RP-33-99 ERRATA

• *Section 8.0, Luminaire Classification*

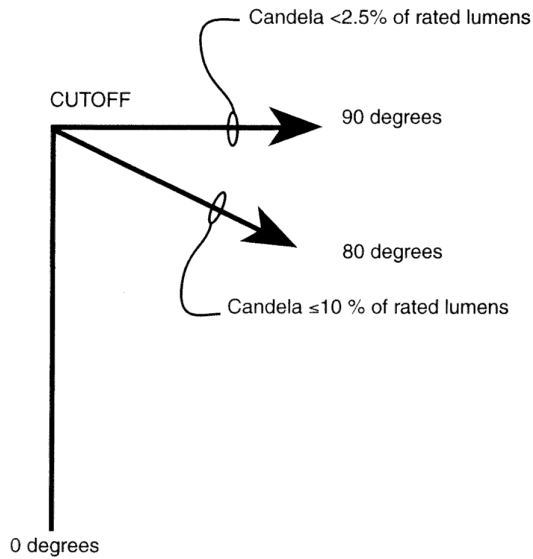
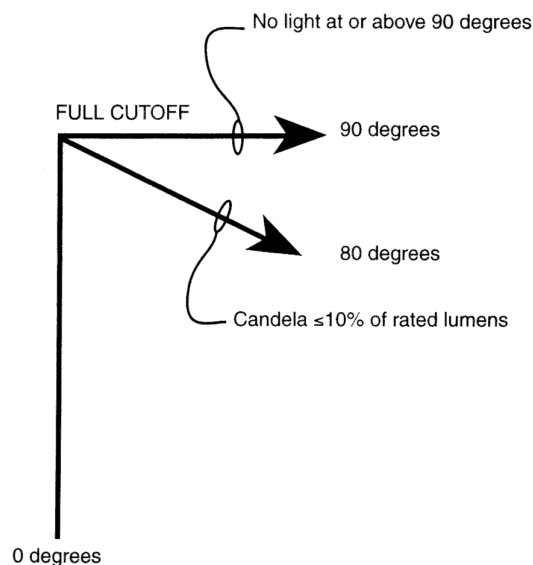
On page 17 in the right-hand column there are definitions given for *four* luminaire cutoff classifications. Illustrations of each definition appear in **Figure 18** (see page 19).

However, *three* of these luminaire cutoff definitions and illustrations (for Full Cutoff, Cutoff, and Semicutoff) do not match the definitions/illustrations presented in RP-8-00, *American National Standard Practice of Roadway Lighting*. (*Note*: The Noncutoff definition and its illustration in RP-33-99 are correct and do not require revision.)

To bring RP-33-99 into exact agreement with RP-8-00, the following definitions and illustrations should be substituted for what appears on page 17 and page 19 in RP-33-99:

Full Cutoff: A luminaire light distribution where zero candela intensity occurs at or above an angle of 90° above nadir. Additionally the candela per 1000 lamp lumens does not numerically exceed 100 (10 percent) at or above a vertical angle of 80° above nadir. This applies to all lateral angles around the luminaire.

Cutoff: A luminaire light distribution where the candela per 1000 lamp lumens does not numerically exceed 25 (2.5 percent) at or above an angle of 90° above nadir, and 100 (10 percent) at or above a vertical angle 80° above nadir. This applies to all lateral angles around the luminaire.

Semicutoff: A luminaire light distribution where the candela per 1000 lamp lumens does not numerically exceed 50 (5 percent) at or above an angle of 90° above nadir, and 200 (20 percent) at or above a vertical angle 80° above nadir. This applies to all lateral angles around the luminaire.
